Response to comments on Clause 24 of Draft 1p1

IEEE 802.3az Task Force
New Orleans, Jan 2009

Joseph Chou

Figure 24-11—Receive state diagram

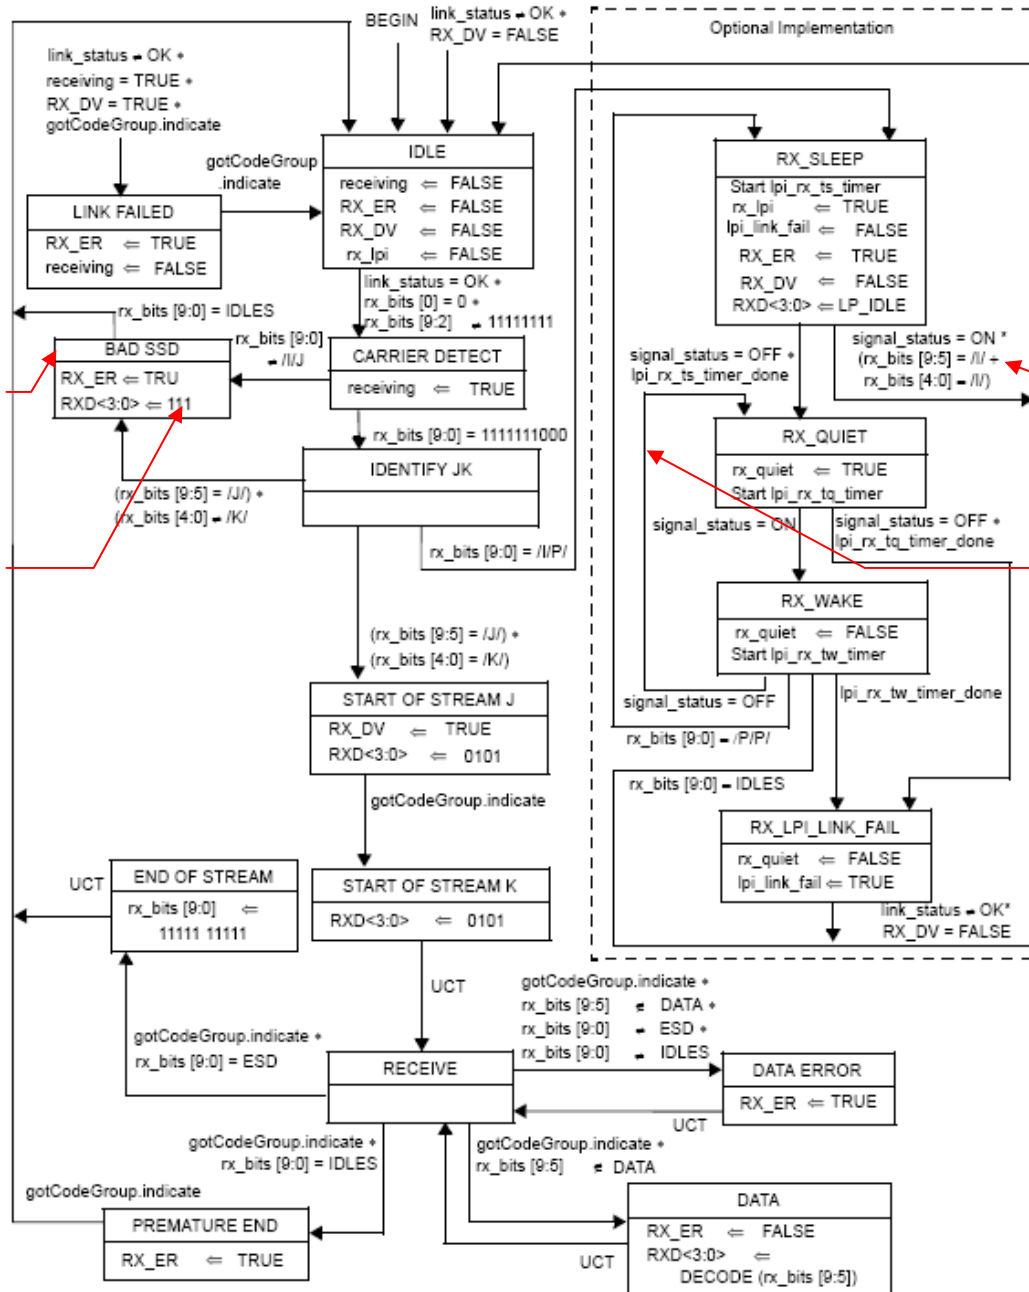
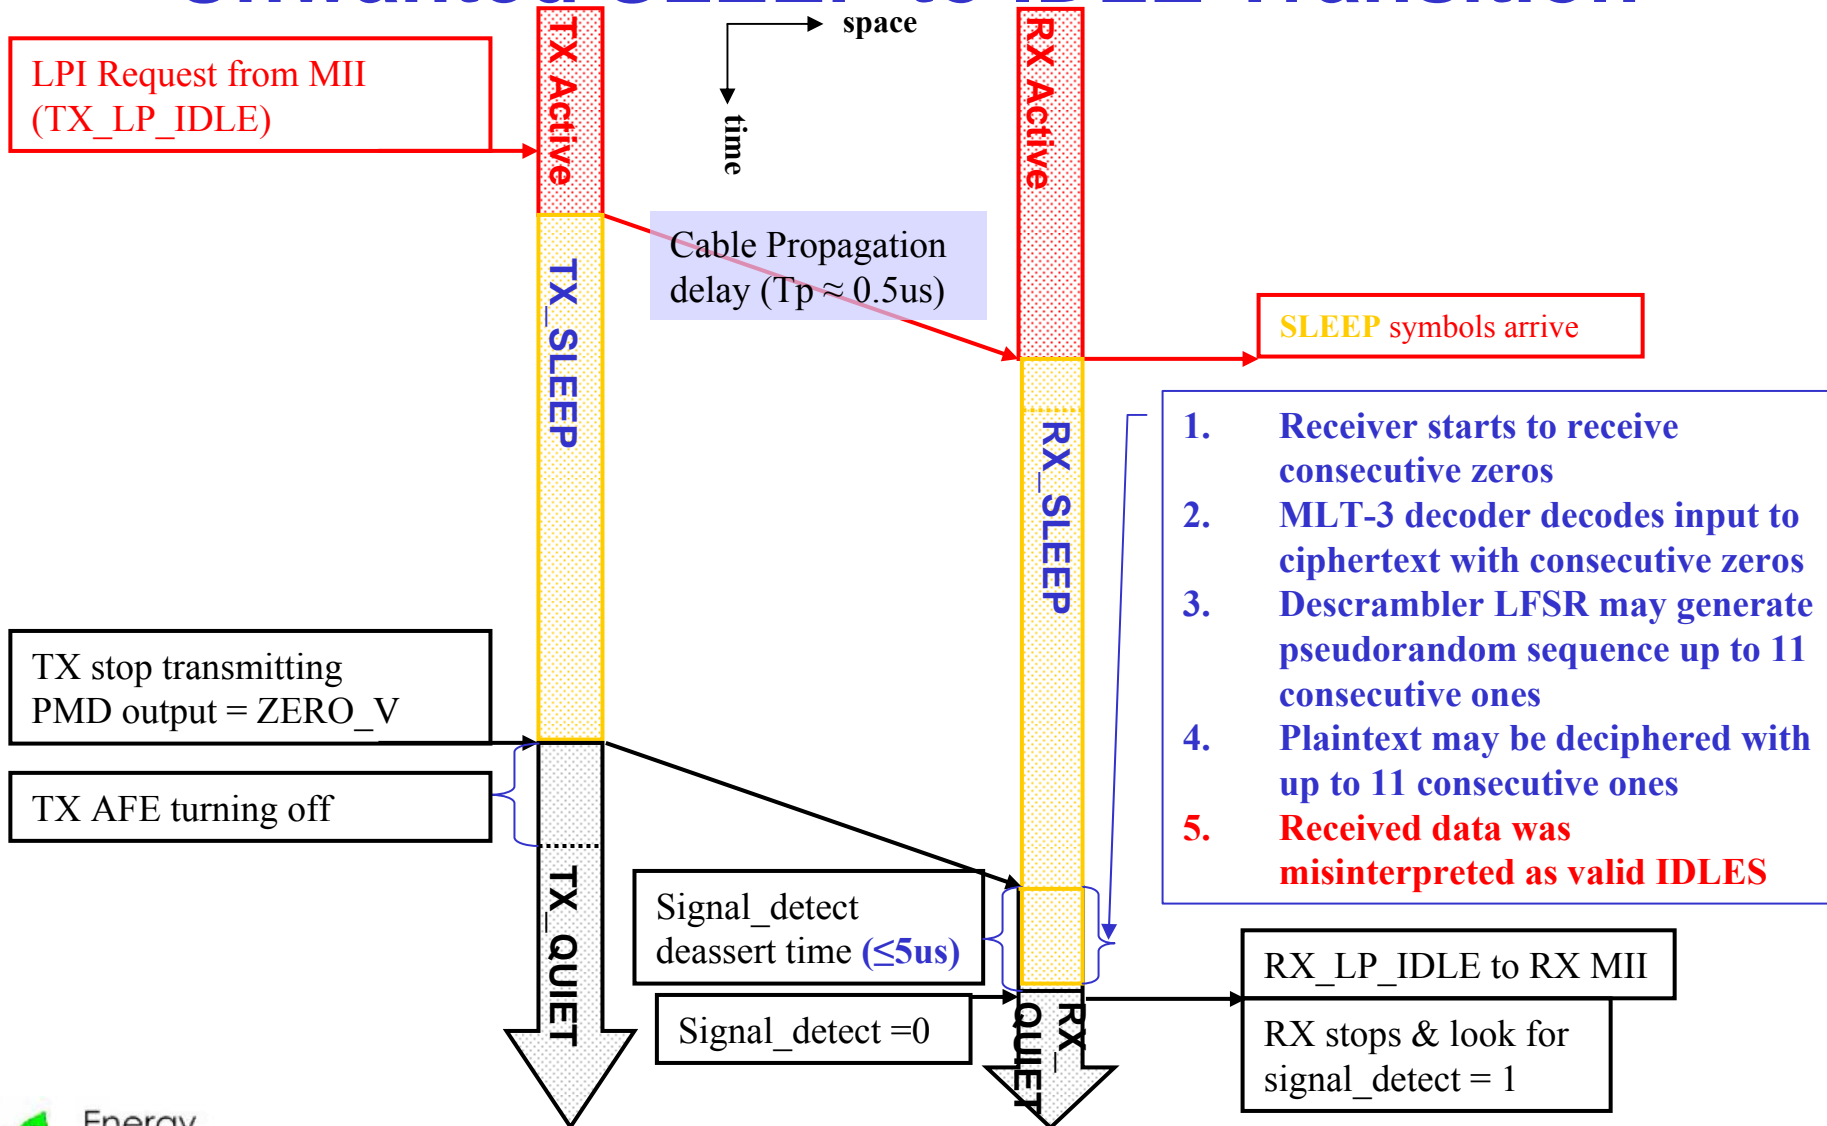
Comment 99
Suggest to Add a transition from BAD SSD to RX SLEEP

Comment 242
Value assignments are incomplete

Comment 74
May accidentally get into IDLE during the transition from RX_SLEEP to RX_QUIET

Comment 88 & 243
May unnecessarily reset the lpi_rx_tq_timer causing indefinite loop between RX_QUIET and RX_WAKE

Comment 74: Unwanted SLEEP to IDLE Transition

Figure 24-11a—Receive state diagram, part a

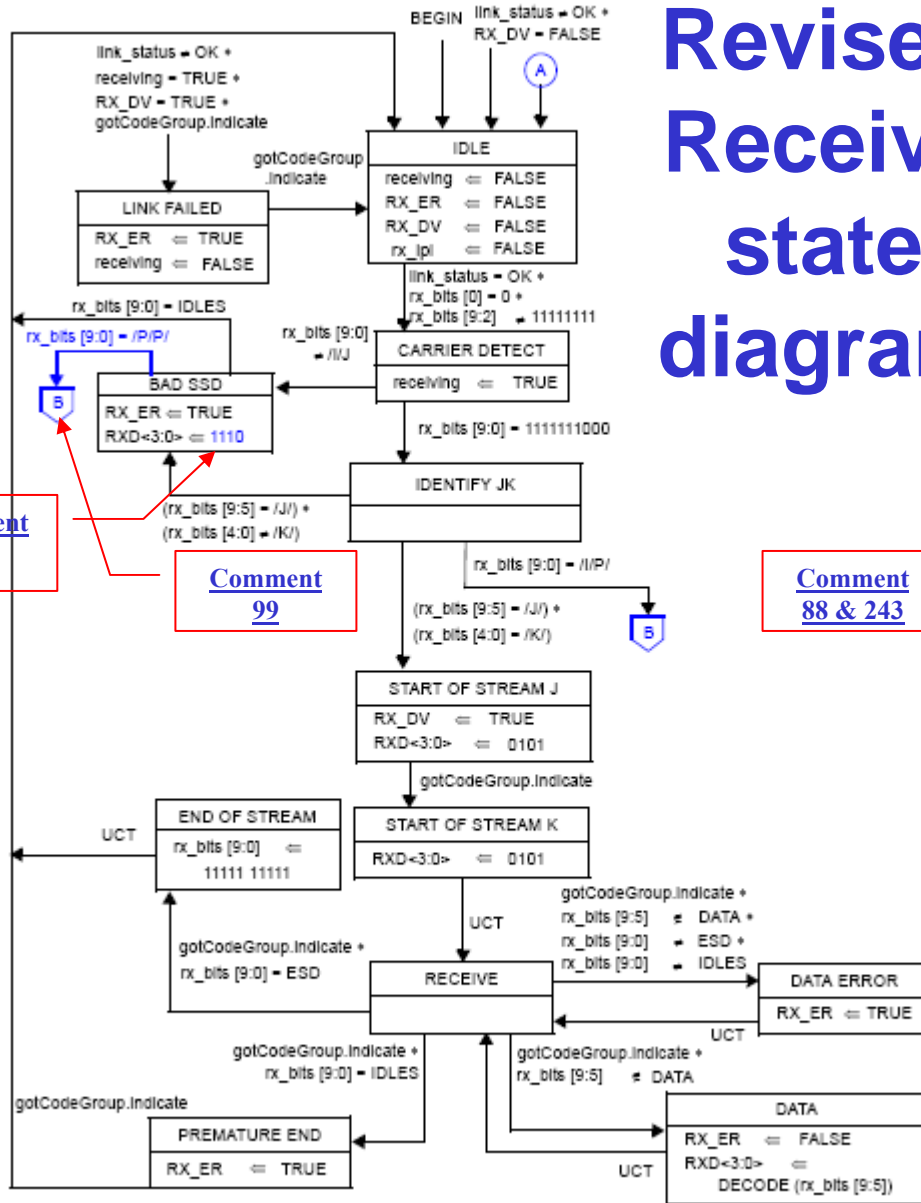
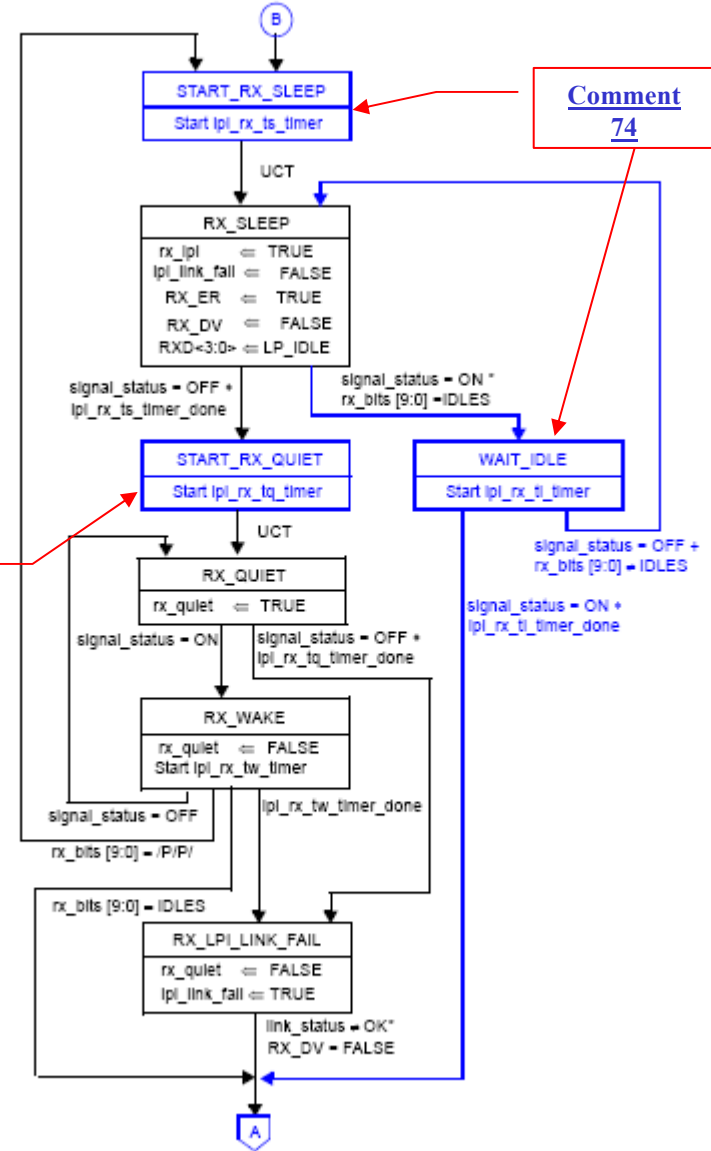
Comment 242

Comment 99

Comment 88 & 243

Comment 74

Comment 74: Remedy

- ❑ Introduce a new state WAIT_IDLE between RX_SLEEP and IDLE
 - Check the minimum duration of IDLE symbols before exiting the low power receive state.
 - Return to RX_SLEEP for conditions other than consecutive IDLE symbols.
- ❑ Add a new timer lpi_rx_ti_timer
 - To count the minimum duration of consecutive IDLE symbols.
 - The maximum number of all ones possibly deciphered during the transition from RX_SLEEP to RX_QUIET is 11 bits time, which is $8 \text{ ns} * 11 = 88 \text{ ns}$.
 - Propose a default value between 1.0us to 1.2 us.
 - This timer won't affect Wakeup time.
- ❑ Add a new state START_SLEEP
 - To avoid resetting the timer lpi_rx_ts_timer during the reentry to RX_SLEEP from WAIT_IDLE

- ❑ Comment 88 & 243 : Introduce a new state START_RX_QUIET as suggested by commentators.
- ❑ Comment 99 : Add a transition from BAD SSD to RX SLEEP with the transition condition $rx_bits[9:0] = /P/P/$ as suggested by commentator.
- ❑ Comment 242 : Variables setting of "BAD SSD" state should be $RXD<3:0> = 1110$ as suggested by commentator. Additionally, $RX_ER = TRUE$ is revised.
